Noise on rear axle model 201

Standardization of rear axle housing for model 124 and 201

ABS speed sensor with modular design

Hole circle diameter on rear axle center assembly joint flange changed from 80 mm to 90 mm

P35-5539-15

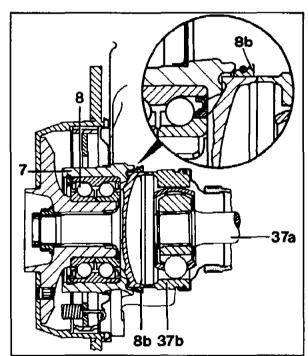
Additional dust cover for rear axle wheel bearing on vehicles used on bad roads

On model 124 and 201 an additional dust cover can be installed. This provides additional dust protection for the wheel bearing seal.

A dust sealing ring (8b) in the form of a slinger ring can be installed on the spider ring (37b) on the rear axle shaft (37a) on vehicles used on bad roads.
